STAFF REVIEW AND RECOMMENDATIONS  
PUBLIC HEARING  
JANUARY 19, 2022

ABBREVIATED PLAT: AROQUESTRIAN ACRES

CASE #: 2021-155

**REQUEST:** The request is to create two lots from Parcel A-1 of MSB Waiver Resolution No. 94-35-PWm (Tax Parcel B15), to be known as **AROQUESTRIAN ACRES**, containing 7.91 acres +/- . The plat is located directly south of E. Palmer-Wasilla Highway, east of N. Loma Prieta Drive and west of N. Hemmer Road; within the NW ¼ Section 06, Township 17 North, Range 02 East, Seward Meridian, Alaska. This has been continued from the October 20, 2021 public hearing.

AROQUESTRIAN ACRES  
A SUBDIVISION OF  
PARCEL A-1  
WAIVER RES. 94-35-PWm  
(BK. 791, PG. 326)

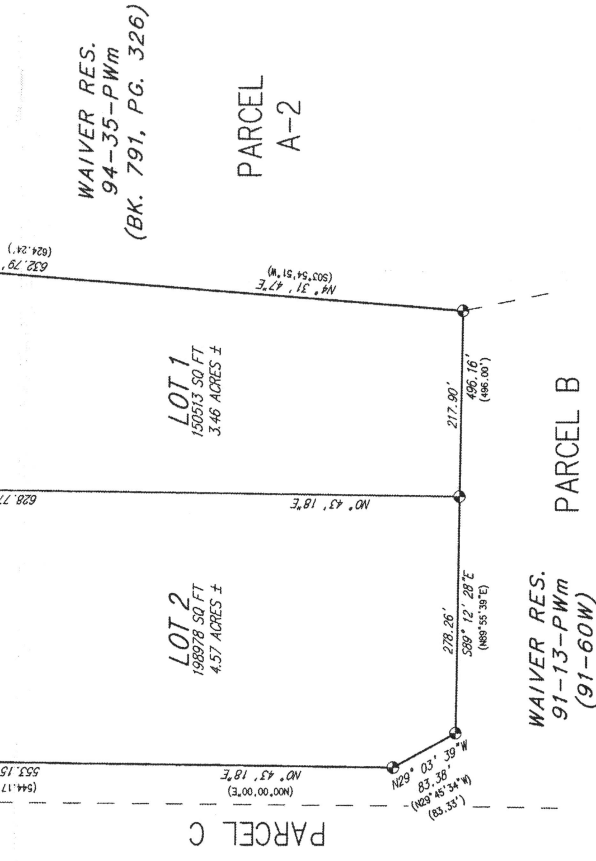
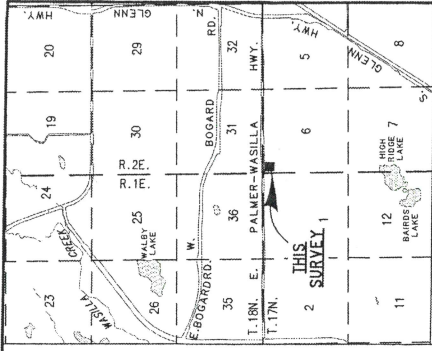
Yep. It looks like they're addressing it, assuming the easement is actually filed with the Recorder's Office as right now, there's no info about it included other than the dashed line showing it will be there. The easement must be filed before the plat is approved.

- As per our letter from 07/28/2021, we object to this plat until access issues are addressed. We won't grant any change to the existing access and no new driveways will be approved. Lot 2 must be granted an easement or legally binding access agreement to use Lot 1's existing driveway. Or a similar easement or access agreement can be established with the existing driveway to the west. This plat should not be approved until Lot 2 has established access to one of the existing driveways.

MTA has the attached 20' easement on lot B15. MTA would like to request this be added to the plat.

3. Pay postage and advertising fees.
4. Show recorded information of 20' access easement on the final plat.
5. Obtain a determination that the structure on the north side of proposed Lot 1 set back approximately 21.1' from the right-of-way and an outbuilding on the east side of proposed Lot 1 set back approximately 7.3' from the side lot line is eligible for Legal Nonconforming Status or remove the structures from the setbacks.

6. Show all easements of record on final plat.
7. Apply for a driveway permit from ADOT&PF for existing driveway and provide copy to Platting staff.
8. Submit recording fees, payable to Department of Natural Resources (DNR).
